### **Anonymous Referee #1**

Review of "Inter-decadal changes in the intensity of the oxygen minimum zone off Concepcion, Chile (36°S) over the last century" by Srain et al.

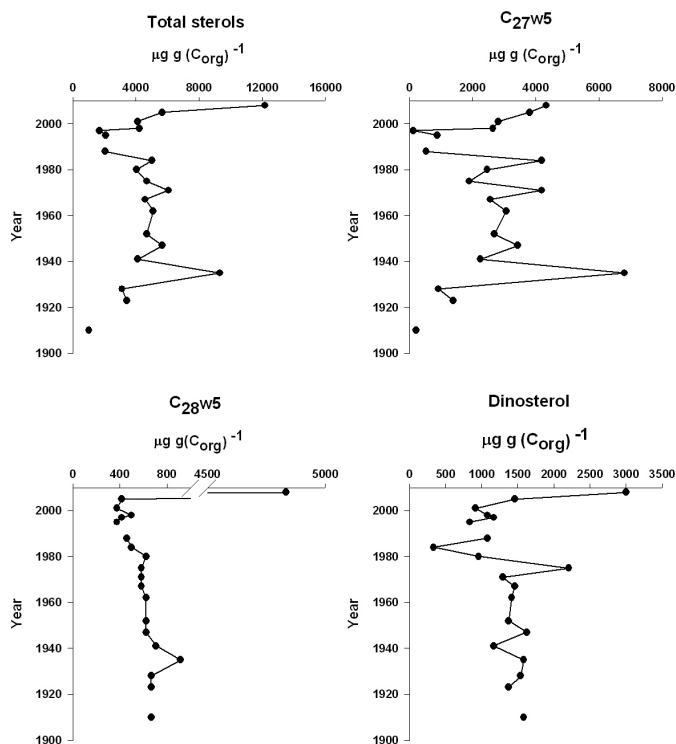
26. Figure 3 and 4: Why are there gaps in the vertical profiles of redox-sensitive metals and biomarkers? Some samples seem to be missing for certain parameters. This needs to be explained!

1. Foremost among these is the curiously different patterns of behavior of the organic biomarkers presented in Figure 4. Only the bacterial biomarkers seem to conform well to the postulated PDO influences on the coring site; the sterols and the GDGTs do not seem to be affected by the PDO cycles, and the MAGEs appear to show some combination of the hopanoid and sterol patterns. These variations

3. Finally, many of the sampled intervals in the core are missing data. Were these proxies below their detection limit in these intervals, were there analytical problems, or were they simply not measured? Explain!

A: Some samples were lost. This is explained in the figure captions of the revised version.

A: We agree that other processes than “oceanography” may be affecting the microbial communities at our site. For example, and in addition to the biomarkers pointed out by the Referee, below are profiles of individual sterols, where we do not detect a clear pattern (see for example dinosterol, a marker of dinoflagellates). However, we do not have the necessary information to conclude about other important processes, and thus we prefer to “gloss over” some of the variations to avoid overinterpretation of our data.

A: In the case of figure 3, the missing data-points refer to lost samples, whereas the gaps in figure 4 indicate that biomarker content was under the detection limit. This is now explained in the respective figure captions of the revised version.
